# ***City of Albuquerque***

**Re: Checker Auto Store, 10030 Central Ave. SE, Certificate of Occupancy  
(L20/D59)**

**RE: CHECKER AUTO (L20-D59). GRADING AND DRAINAGE PLAN FOR BUILDING AND GRADING PERMIT APPROVALS. ENGINEER'S SEAL DATED June 29, 1998.**

**RE: CHECKER AUTO (L20-D59). GRADING AND DRAINAGE PLAN FOR BUILDING  
AND GRADING PERMIT APPROVALS. ENGINEER'S SEAL NOT DATED.**

SECTION B-B

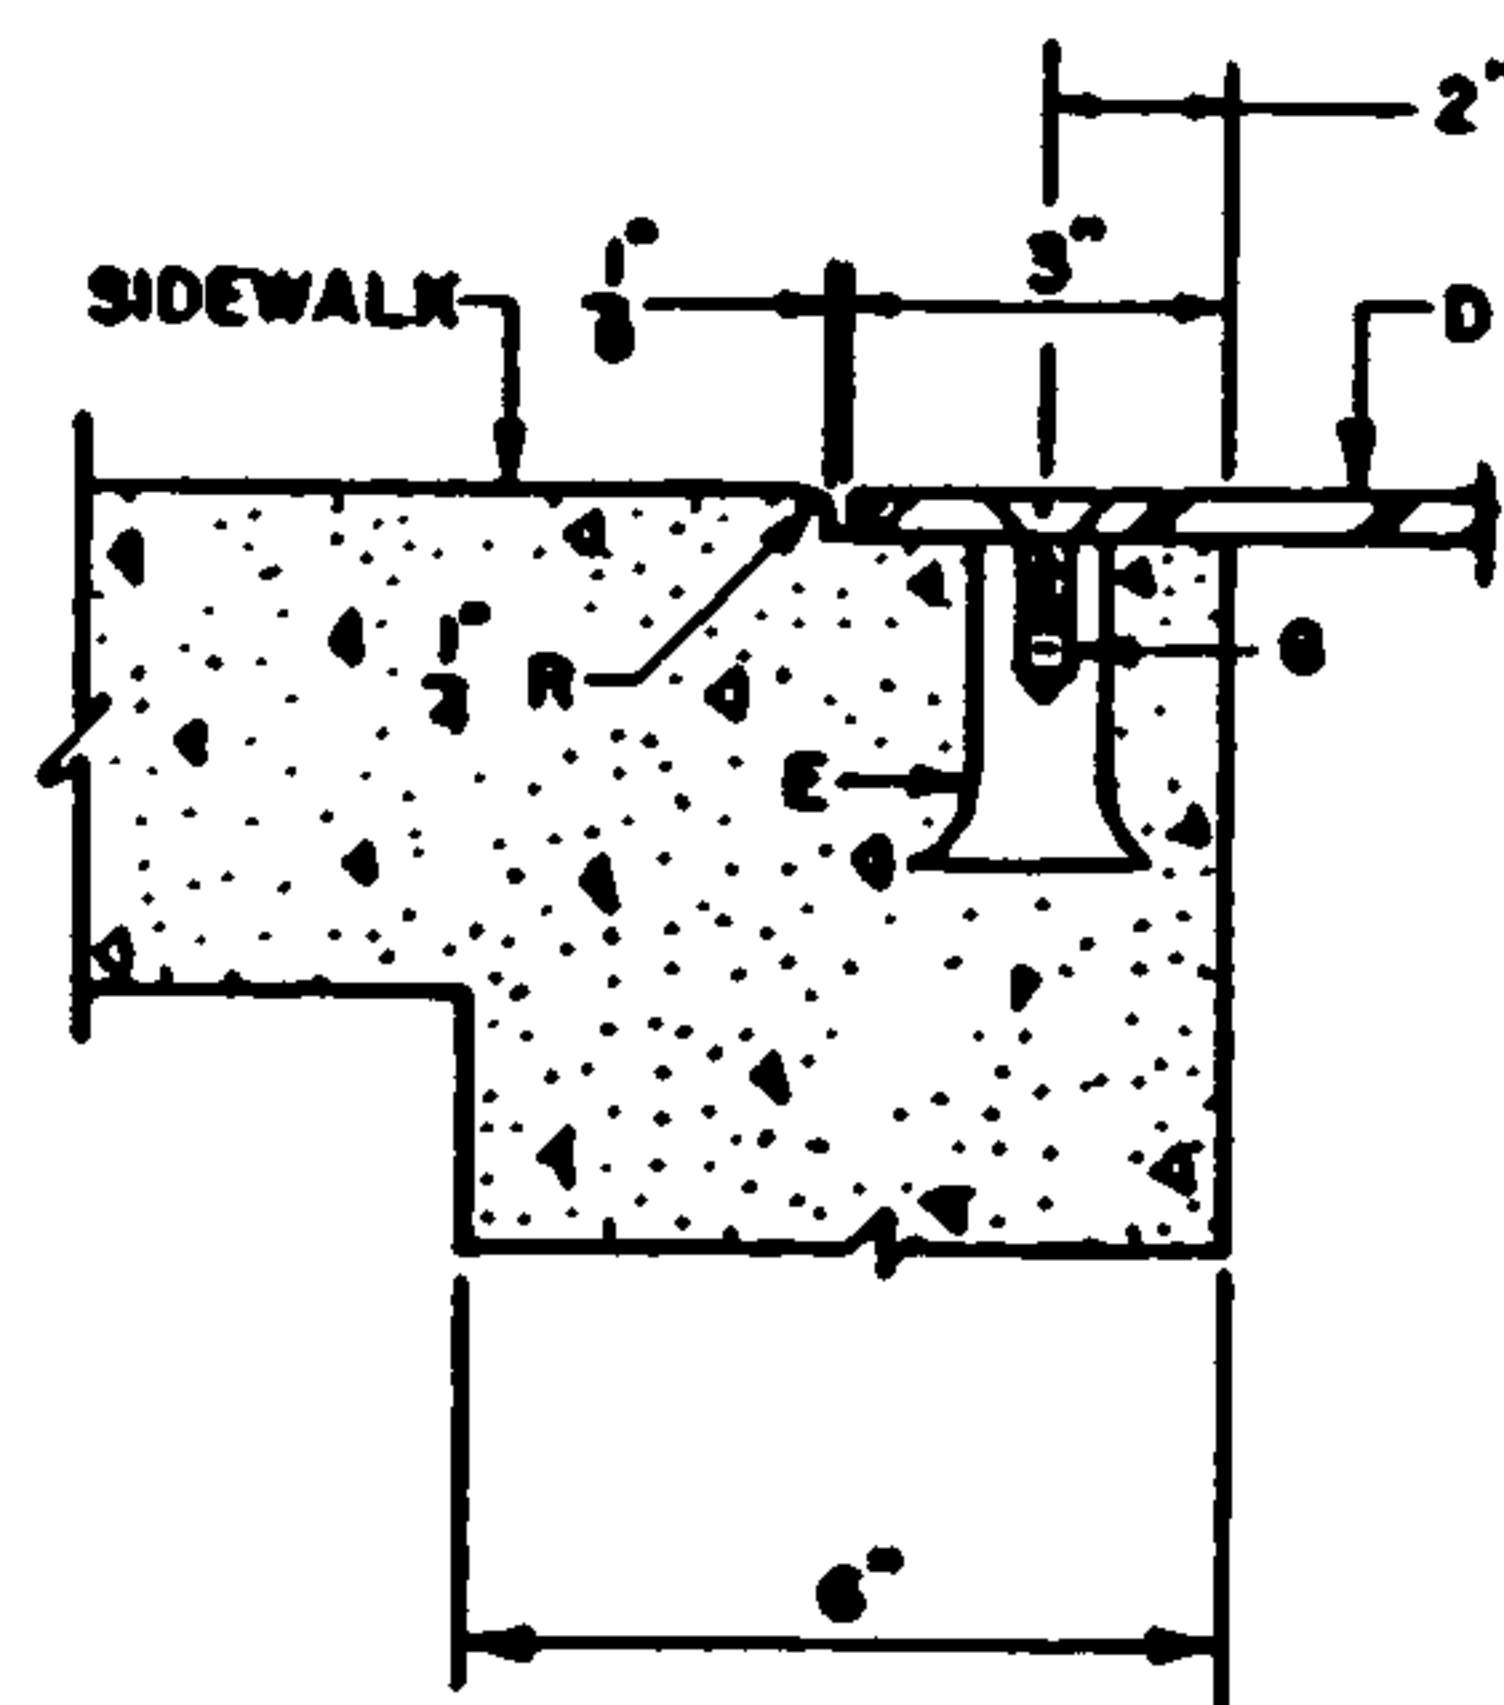
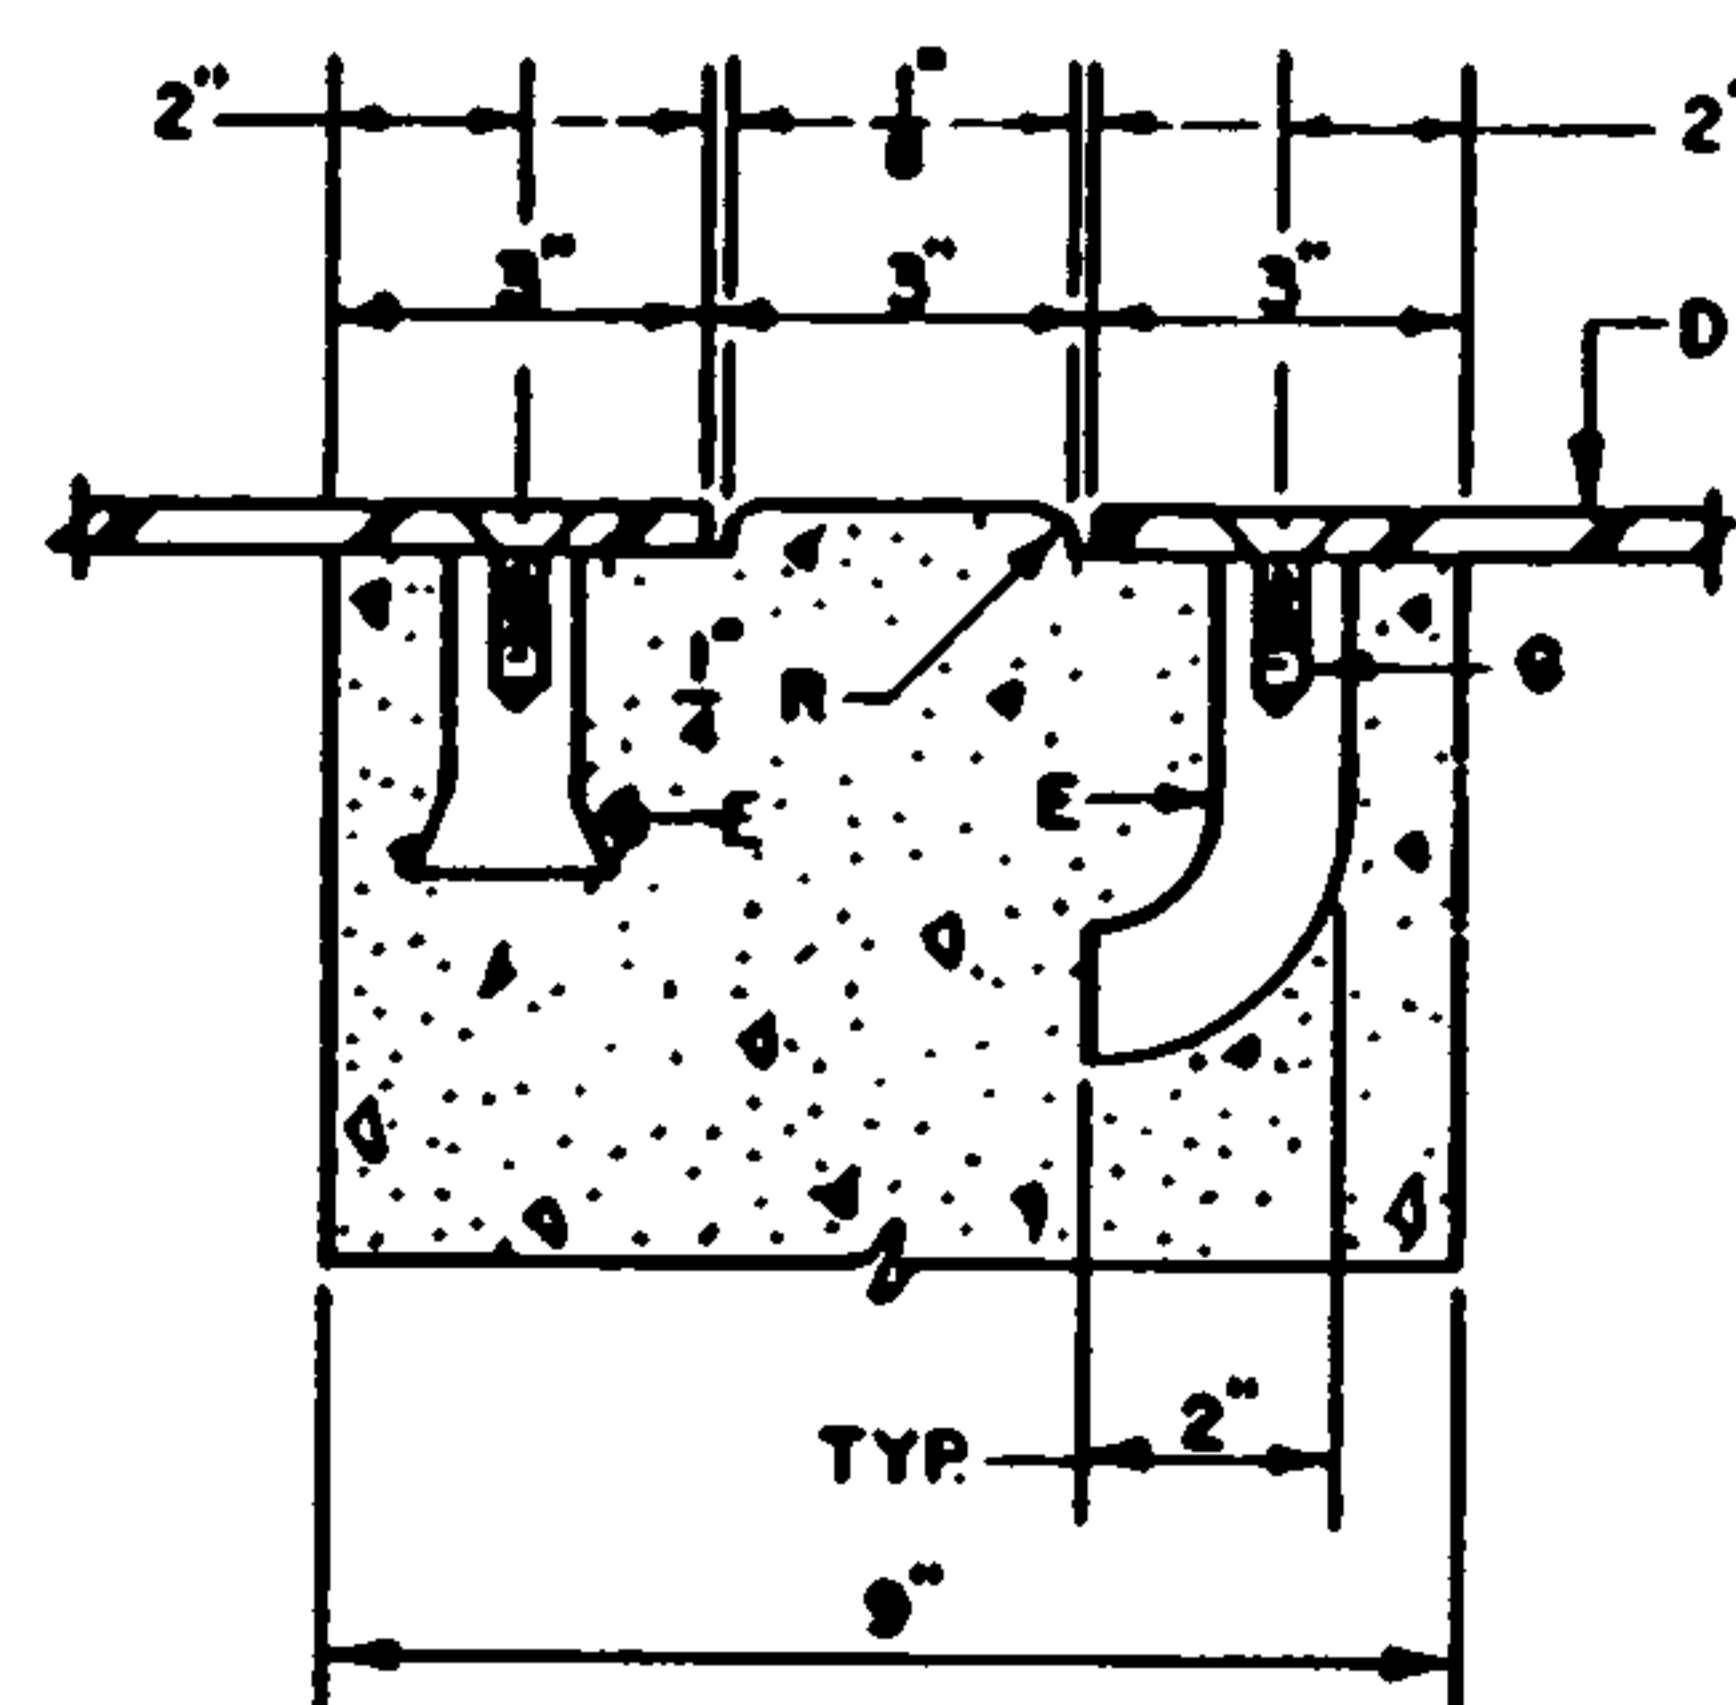
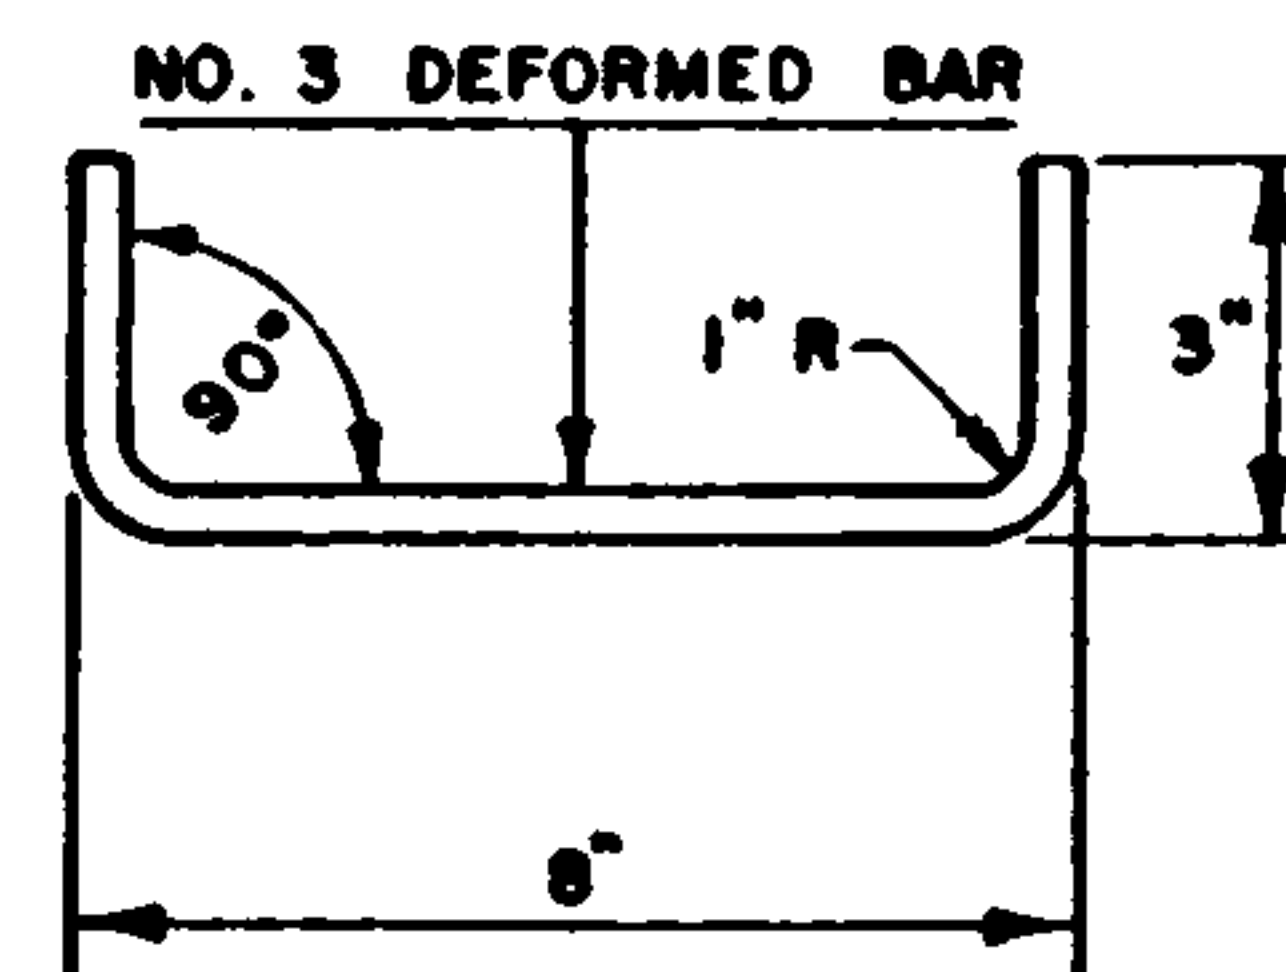
Sidewalk culvert is standard. Refer to City of Albuquerque Standard Drawing 2236 (copy enclosed). Delete detail on Sheet C2. Show calculations for its sizing.
